SK3351R00-01

CONTRACT CHANGE ORDER NO. _____
SHEET _____ OF _____

SAN FRANCISCO OAKLAND BAY BRIDGE
EAST SPAN SEISMIC SAFETY PROJECT
SELF-ANCHORED SUSPENSION BRIDGE
(SUPERSTRUCTURE & TOWER)

E2 SHEAR KEY ANCHORAGE: GENERAL ARRANGEMENT

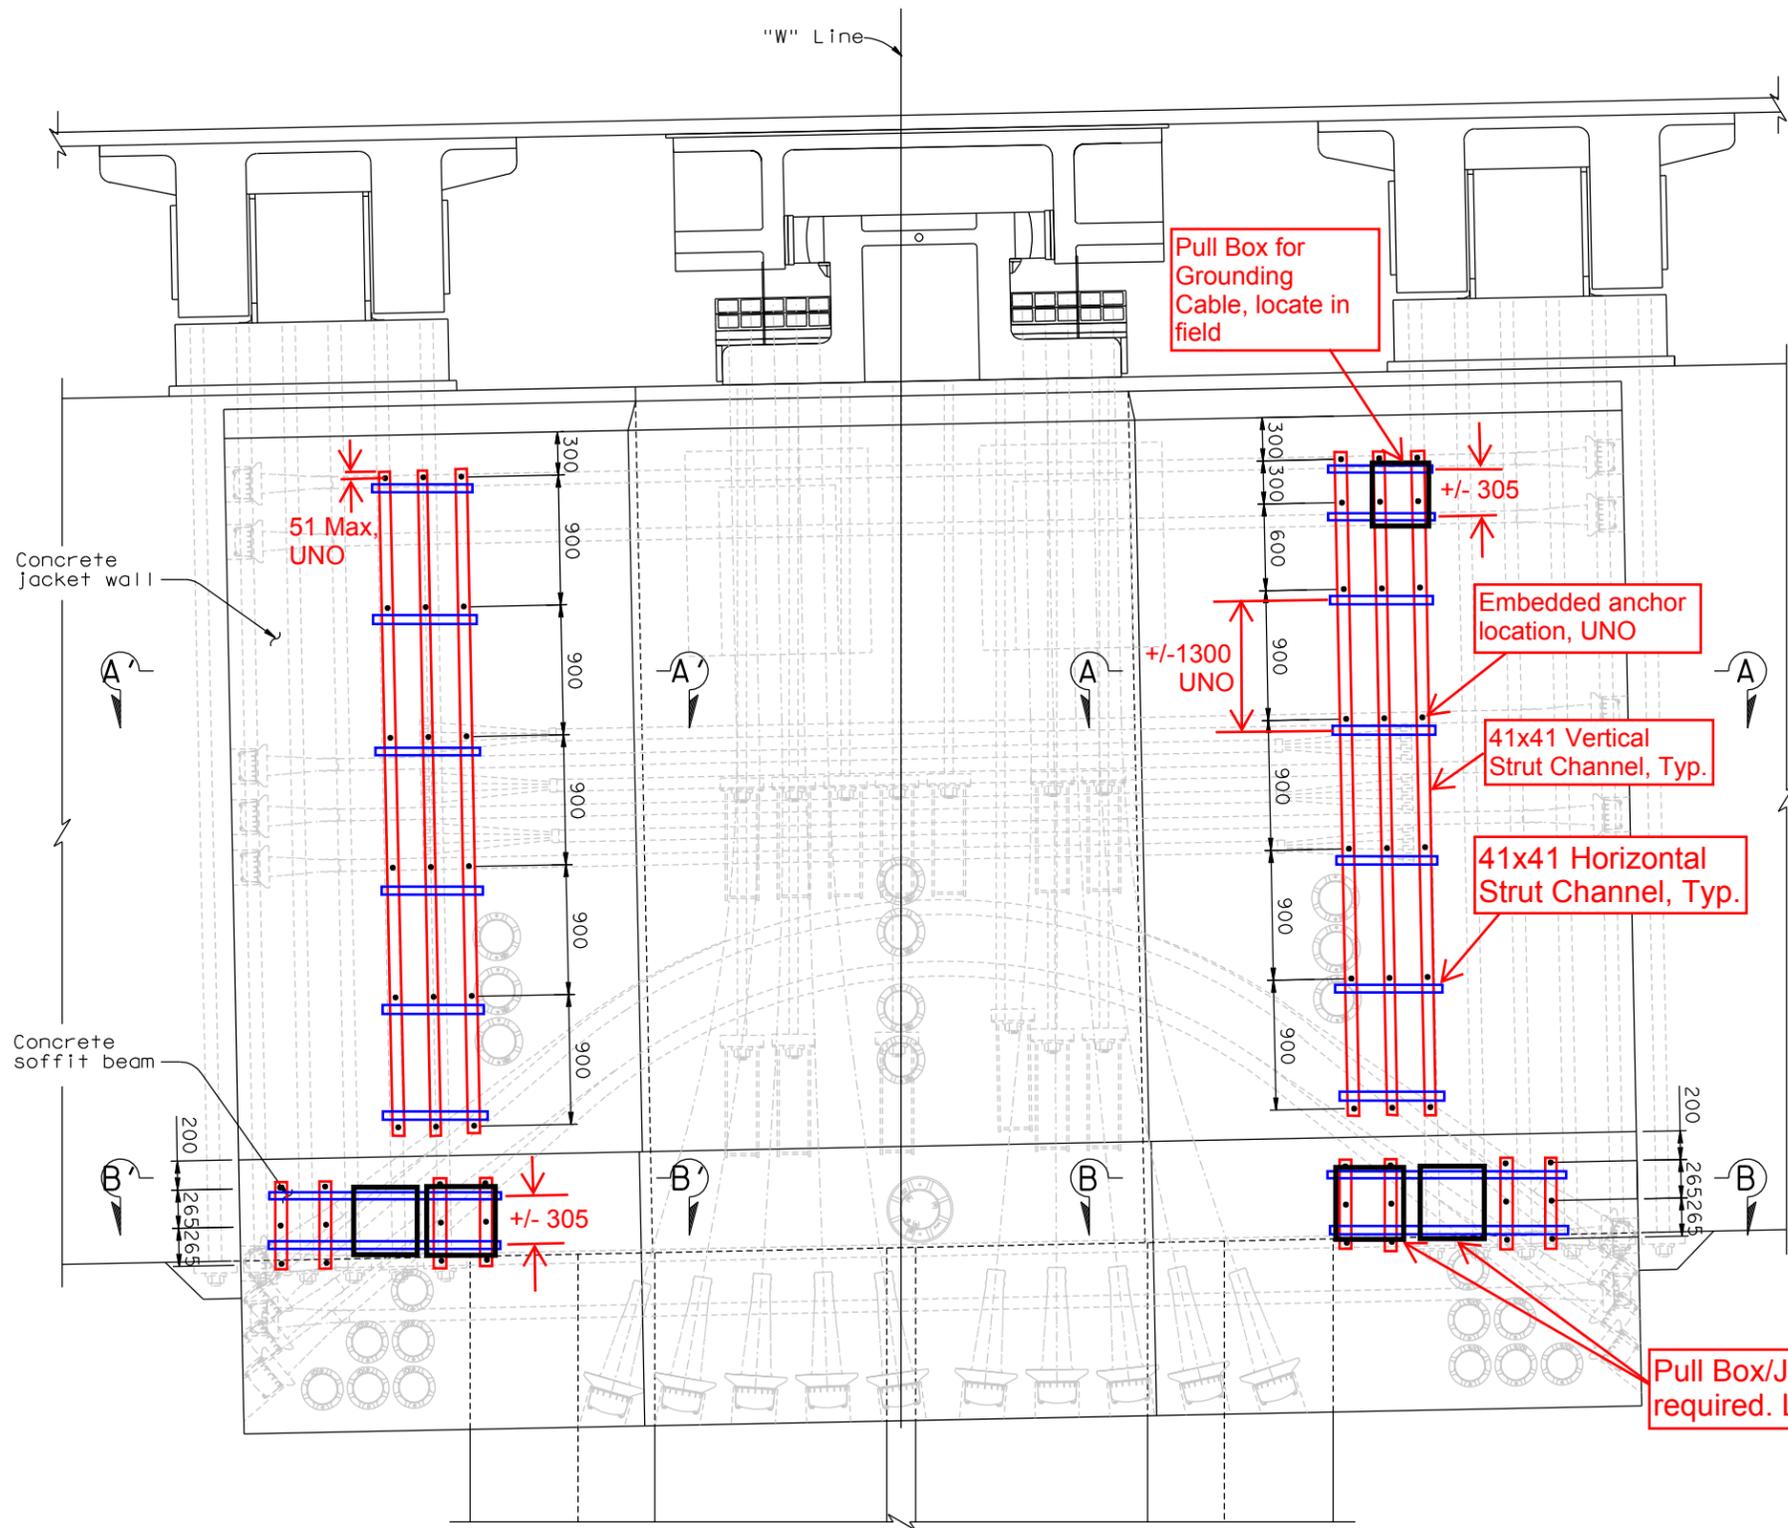
Embedded struts are NOT acceptable. See sketch SK3351R00-02 for alternate Conduit/Pull Box mounting configuration

Embedded struts are NOT acceptable. See sketch SK3351R00-02 for alternate Conduit/Pull Box mounting configuration

Install Junction/Pull Box at the face of the Soffit Beam. Install cable grips inside the junction/pull box for cable drops (size as required)

Location of Junction/Pull Box as shown is NOT acceptable

SK3351R00-02

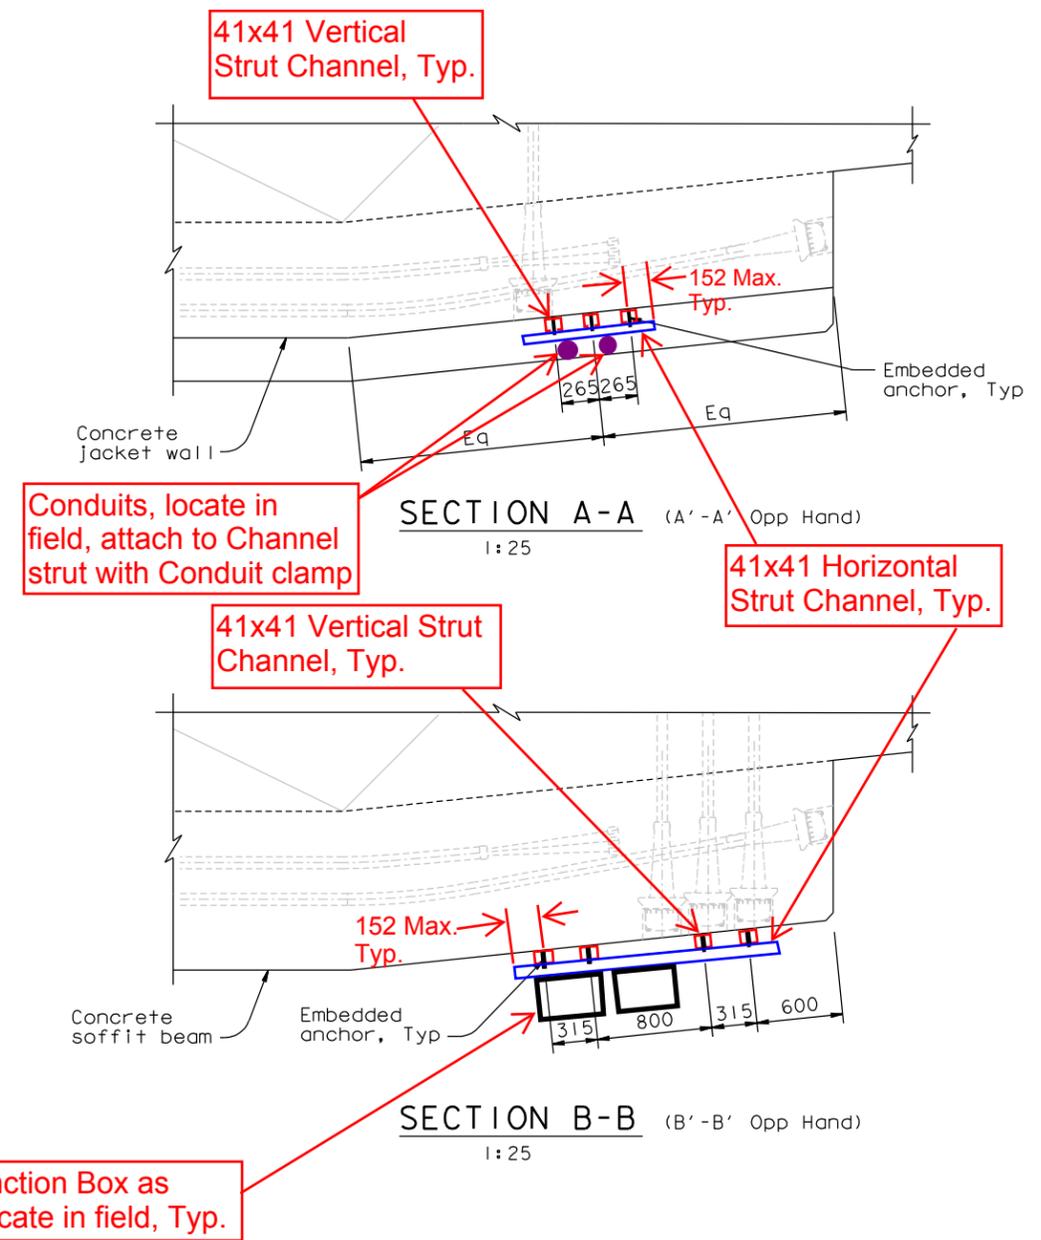
Conduits, locate in field, attach to Channel strut with Conduit clamp

Pull Box/Junction Box as required. Locate in field, Typ.

Embedded Anchor and Vertical Conduit Support Channel Strut Connection Detail

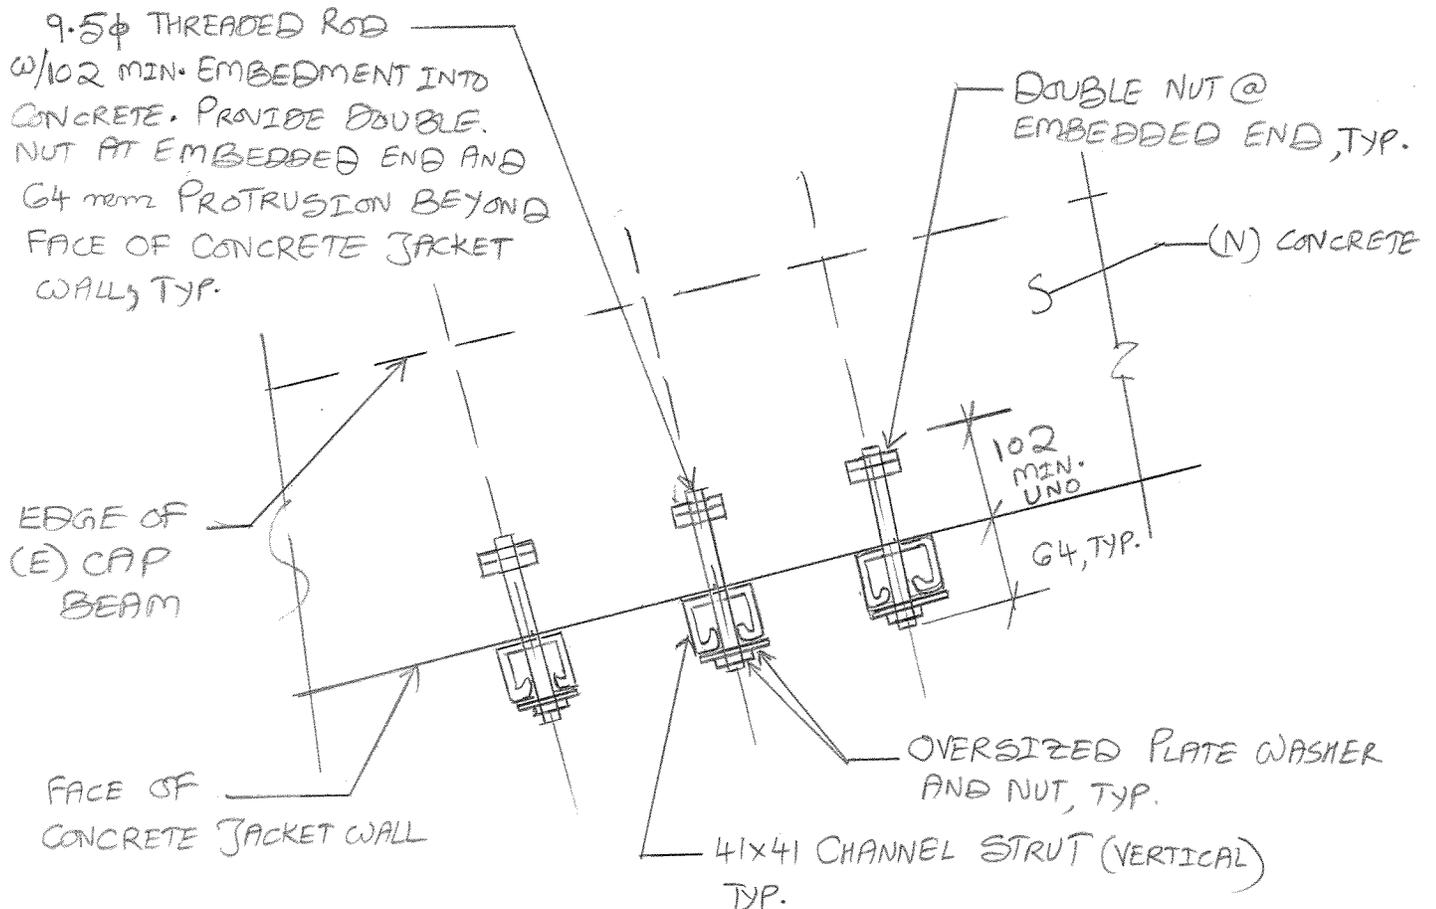
1) Contractor shall ensure all embedded anchors are aligned along a straight vertical line per sketch SK3351R00-02. Embedded anchors shall not conflict with Saddle Assembly, PT Ducts or Concrete Jacket Wall reinforcement.

2) All embedded anchors and Channel struts shall be hot-dipped galvanized.

3) Connection at Concrete Jacket Wall is shown, connection at Soffit Beam is similar.

Horizontal Conduit Support Channel Strut and Conduit Attachment Detail

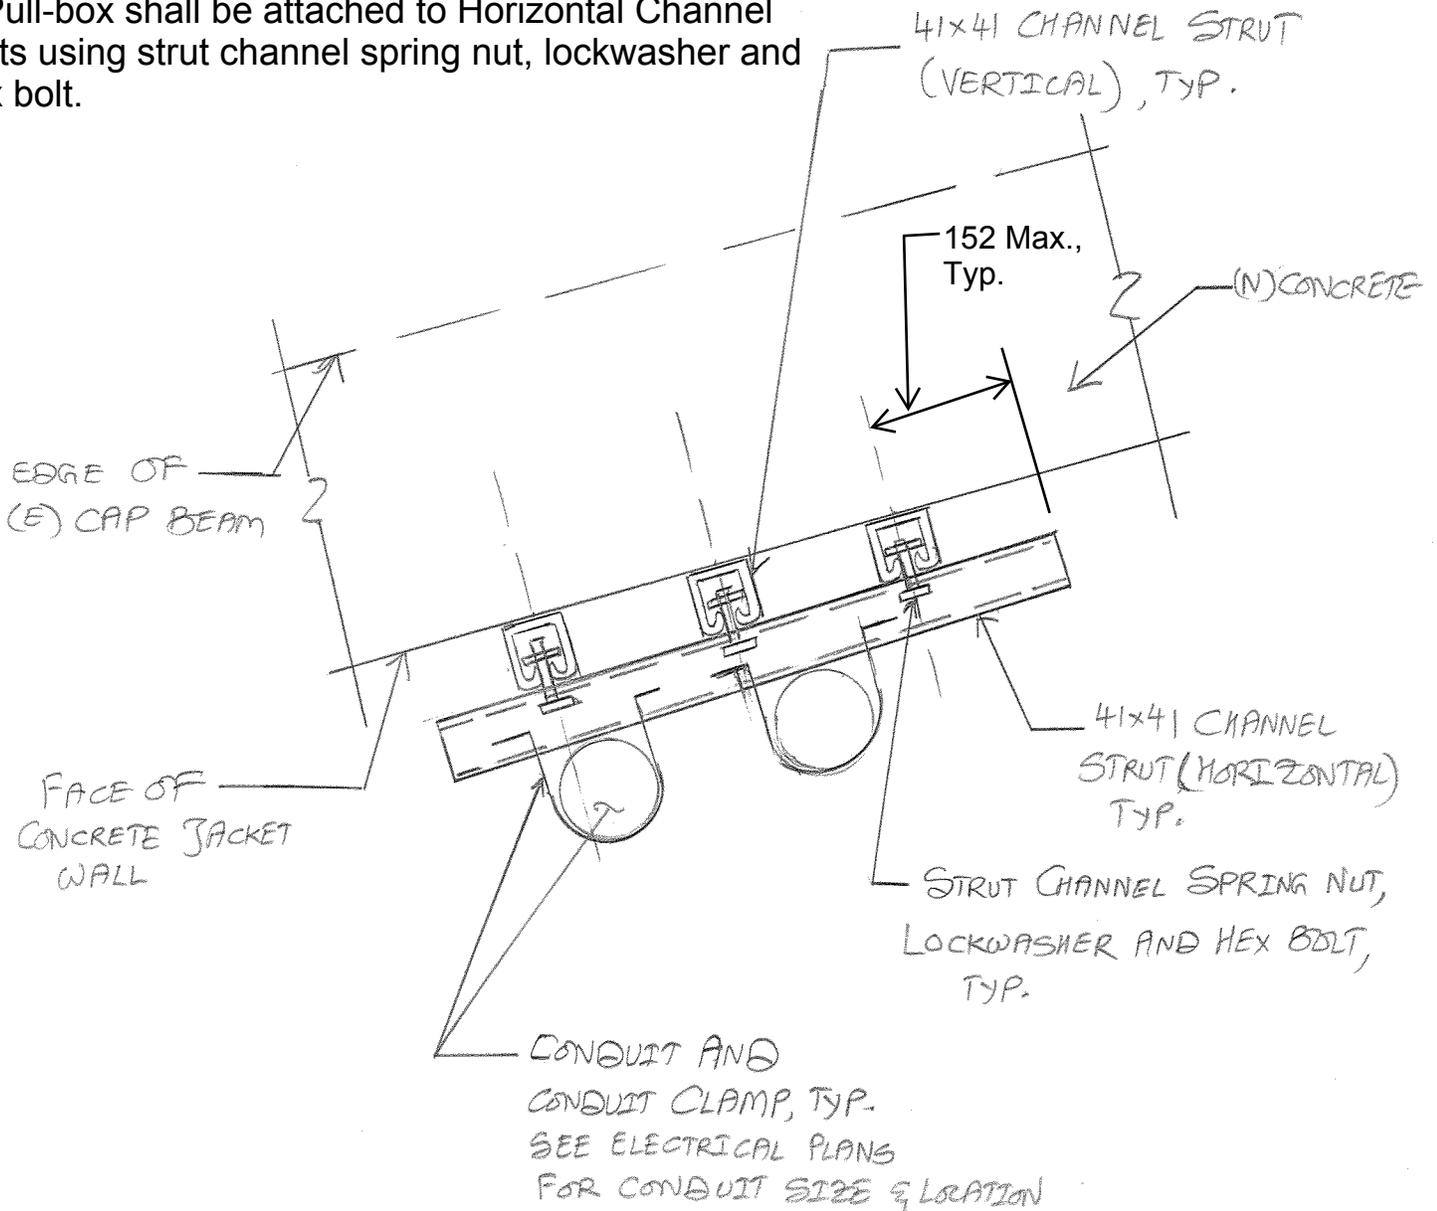
1) Contractor shall ensure all Vertical Channel struts are aligned along a straight vertical line.

2) All Channel struts and fittings shall be hot-dipped galvanized.

3) Connection at Concrete Jacket Wall is shown, connection at Soffit Beam is similar.

4) Pull-box shall be attached to Horizontal Channel struts using strut channel spring nut, lockwasher and Hex bolt.
